Determination 2011/111

The code compliance of barriers to a swimming pool formed by a stair and landing balustrade at 6 Winn Road, Freemans Bay, Auckland

Figure 1: Elevation showing the stair landing and balustrade

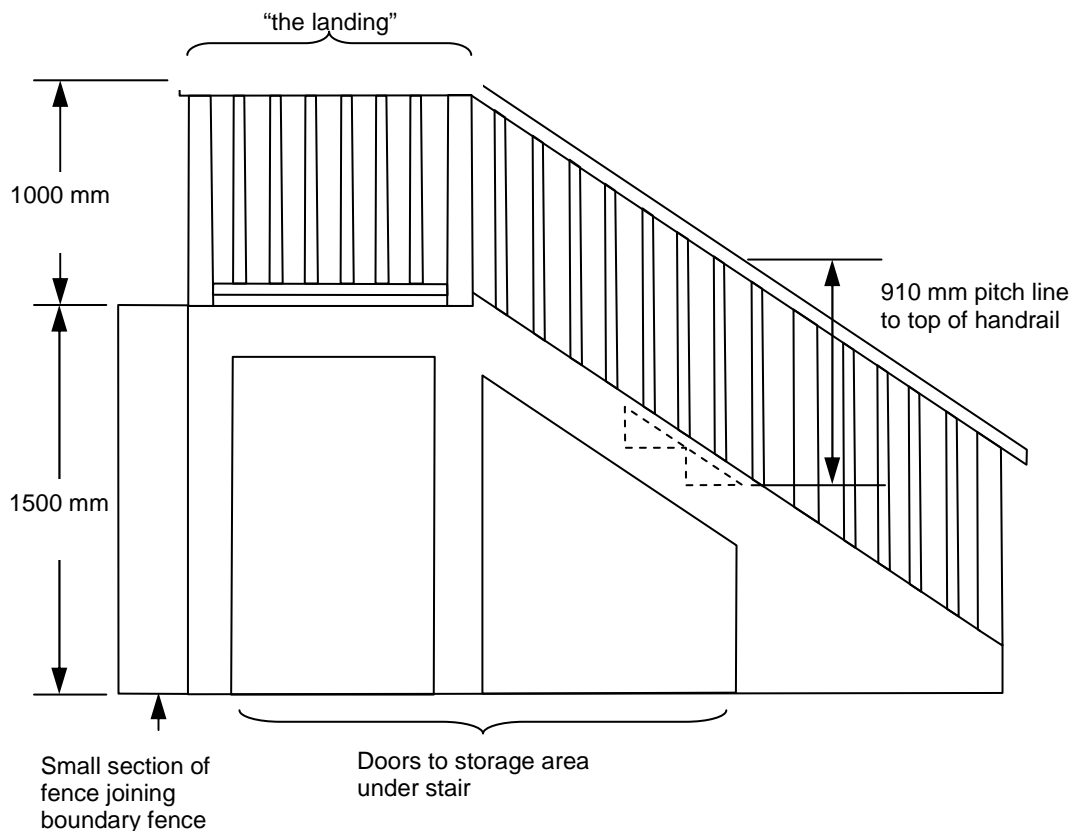
- 5.3.9 The current stair balustrade, if measured from the pitch line of the stair, is 910mm high; the solid rail to the bottom of the stair balustrade provides a toehold to the

barrier. The landing balustrade is 1000mm high; with the bottom rail providing a toehold that makes the balustrade easier to climb.

- 5.3.10 Given that the location of the bottom rail to landing balustrade and the solid barrier to the bottom of the stair barrier, it is unlikely that there is a distance of 900mm between the top and bottom rails to either barrier, as required by clause 5A(a) of the Schedule.

- 5.3.13 Determination 2009/12 considered the elements of the barriers, to both the stair and landing, and came to the view that these elements, in particular the wide top rail, were sufficient to make the barriers as difficult to climb as a barrier described in F4/AS1. In this instance, there does not appear to be anything unusual or exceptional about the elements making up the barrier, i.e., their size or placement, that would compensate for the barriers' inadequate height, as was the case in Determination 2009/12.

- 5.3.14 Accordingly, I conclude that the stair and landing barriers do not comply with Clauses F4.3.4(b) or F4.3.4(f) of the Building Code and the authority was correct to refuse to issue a code compliance certificate.

- 6.1 The authority should now issue a notice to fix requiring the owner to bring the pool barrier into compliance with the Building Code, however, it should not specify how

that is to be achieved. That is a matter for the owner to propose, by way of an amendment to the building consent, and the authority to accept or reject.
